Proposal for:
Supplement 10 to the 07 Series of Amendments,
Supplement 02 to the 08 Series of Amendments and
Supplement 03 to the 09 Series of Amendments

of UN Regulation No. 14 (Safety-belt anchorages)

This proposal is based on informal document GRSP-72-25 and aims at adding alternative anchorage positions to UN Regulation No. 14 in order to enable extended use positions. Amendments to the text of UN Regulation 14 are indicated in bold or strike-through.

“Figure 3

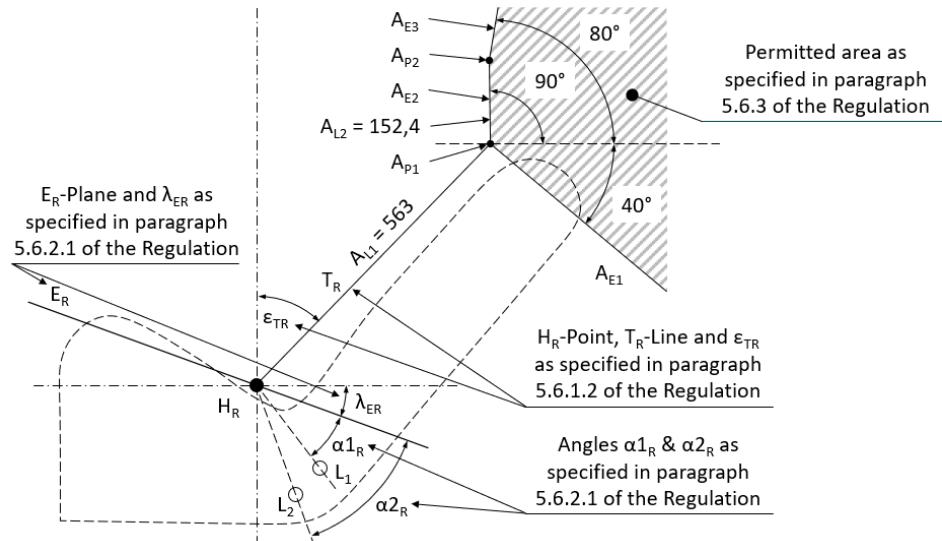
5.6.3. Location of the effective upper belt anchorages (see Figure 3 of Annex 3)

The position of the effective upper belt anchorage point(s) shall be within the permissible area shown in Figure 3 of Annex 3 to this Regulation starting from the H_R-point.

Starting from the H_R-point, the permissible area for the effective upper belt anchorage point(s) is determined with the following segment distances and planes:

A_{L1} A segment of the torso line T_R measured in an upward direction from H_R and 563 mm long and ending in the point A_{P1};

A_{L2} segment distance of 152.4 mm length, measured vertically upwards from the A_{P1} point and ending in the point A_{P2}

A first plane A_{E1} , inclined backwards by 40° from the horizontal, is created backwards from point A_{P1} .

A second plane A_{E2} is created perpendicular to the longitudinal center plane of the seat between points A_{P1} and A_{P2} .

A third plane A_{E3} , inclined horizontally by 80° forwards, is created backwards from point A_{P2} .

The permissible area for the effective upper belt anchorage point(s) is located behind the three planes A_{E1} , A_{E2} and A_{E3} .

Areas of location of effective belt anchorages according to paragraph 5.6.2 and 5.6.3 of this Regulation for extended use positions

All dimensions are in mm”

“Figure 4

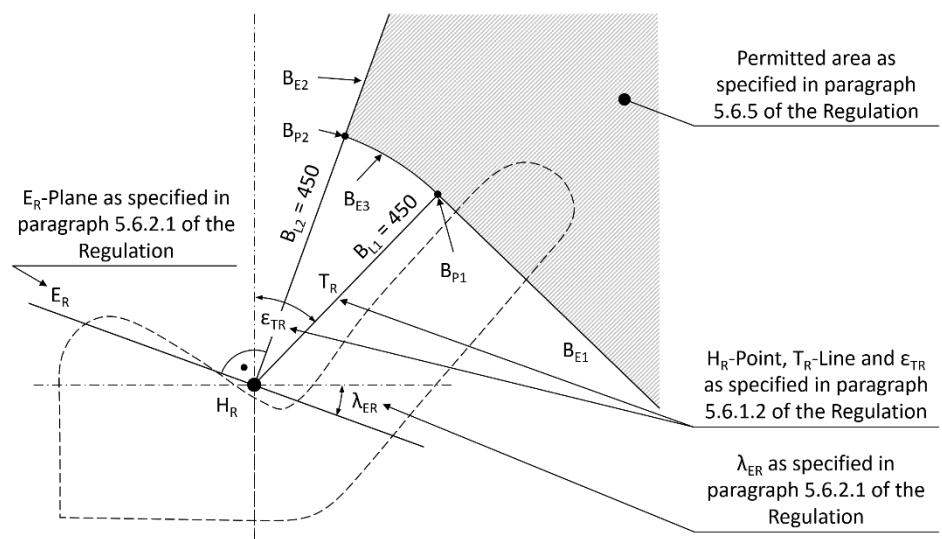
Based on the H_R -point, determine the permissible area shown in Figure 4 of Annex 3 to this Regulation for the effective upper belt anchorage point(s) during the test with the following segment sections and planes:

B_{L1} A segment of the torso line T_R measured in an upward direction from H_R and 450 mm long, ending with the point B_{P1}

B_{L2} A segment distance of 450mm length, measured from the H_R -point perpendicular to the E_R -plane upwards, ending with the point B_{P2}

A first plane B_{E1} is created backwards perpendicular to the torso line T_R and perpendicular to the longitudinal center plane of the seat at point B_{P1} .

A second plane B_{E2} is created upwards perpendicular to the E_R -plane and perpendicular to the longitudinal center plane of the seat at point B_{P2} .

A shell surface B_{E3} is created with a radius of 450mm in the H_R -point between the points B_{P1} and B_{P2} perpendicular to the longitudinal center plane of the seat.

The effective upper belt anchorage point(s) shall not move below or in front of the planes B_{E1} and B_{E2} as well as shell surface B_{E3} during the test.
“

Permitted area of location for upper effective belt anchorages according to paragraph 5.6.5 of this Regulation for other use positions than normal ones

All dimensions are in mm”
